Lyle Creek
Post Closeout Contingency Update
Full Delivery Site

DMS ID (IMS) # 94643
Catawba County
Stream & Wetland Mitigation Site

The Lye Creek closeout site visit was completed with the Interagency Review Team (IRT) on 6/20/2017. The IRT considered a total of 5,571 SMUs and 7.1 WMUs for closure during the site visit. The site was not approved for closure in June 2017, the following plan of action was approved:

Wetland Gage Attainment Summary

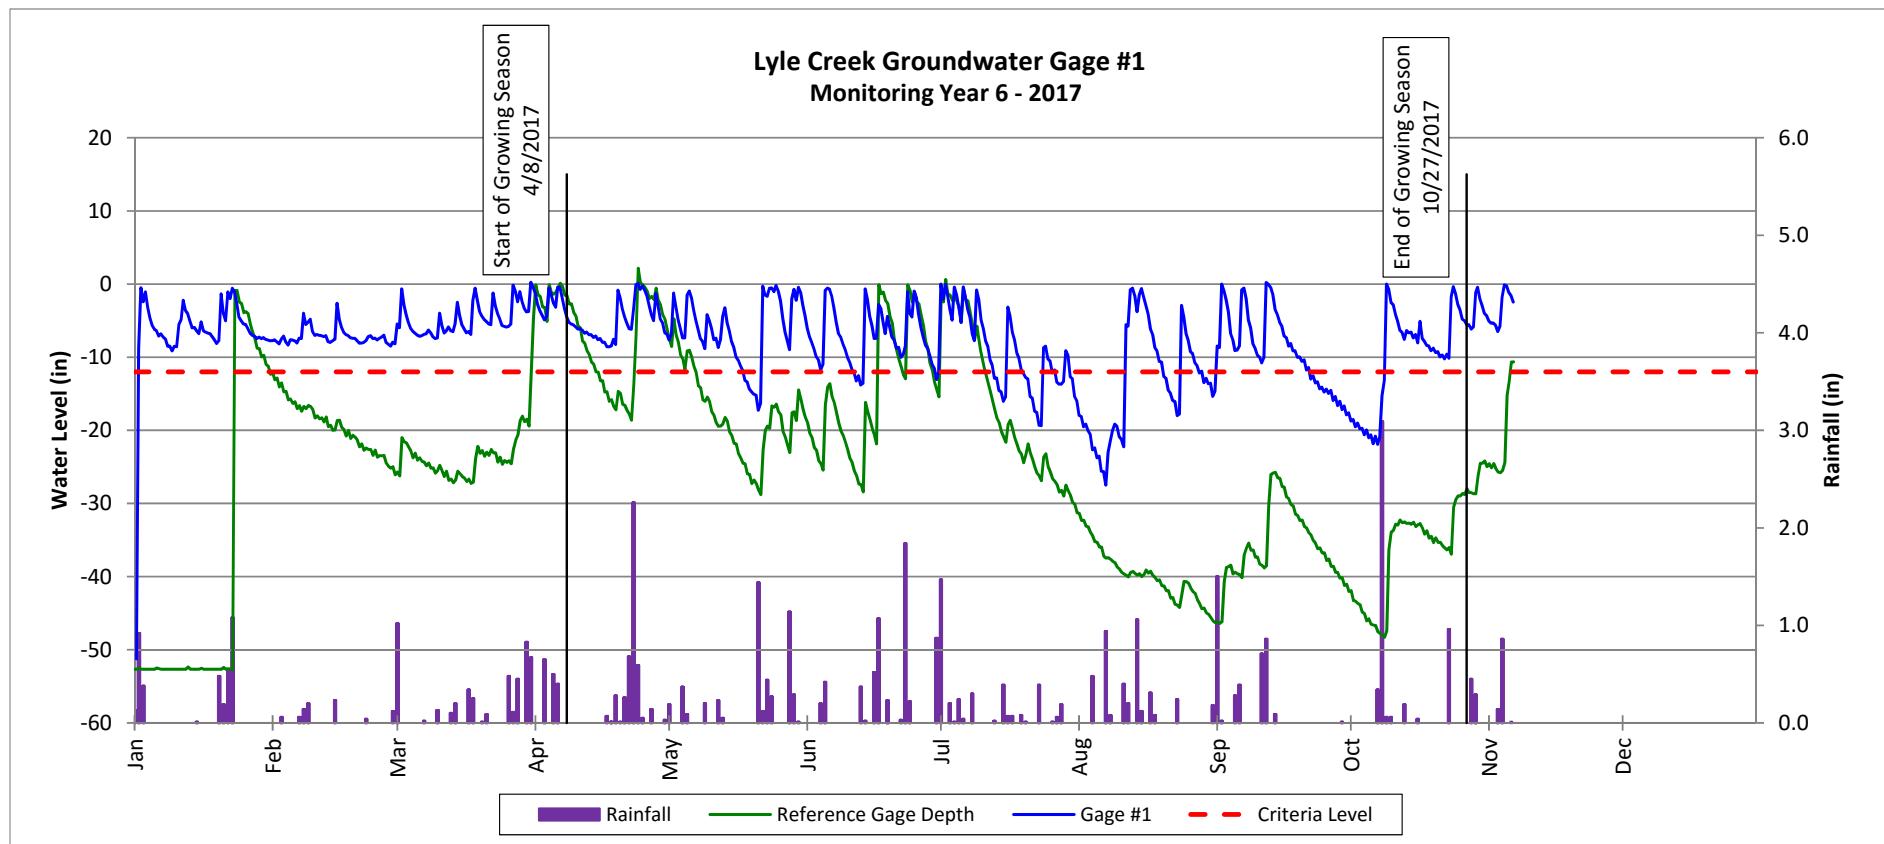
1. Monitor wetland hydrology for one additional year (MY6-2017).
2. Monitor stream reaches UT1 (upstream reach) and UT1b (upstream reach) visually for one additional year.
3. Continue beaver management as necessary for one additional year.
4. Fixed plot vegetation height data to be submitted to the IRT (wetlands only).
5. Eliminate and replant minor landowner encroachments in a few locations.

1. All groundwater gages within the Site met the project success criteria (14 consecutive days, 7.0% of growing season) for Year 6. Please see attached summary gage table and plots for Year 6 results.
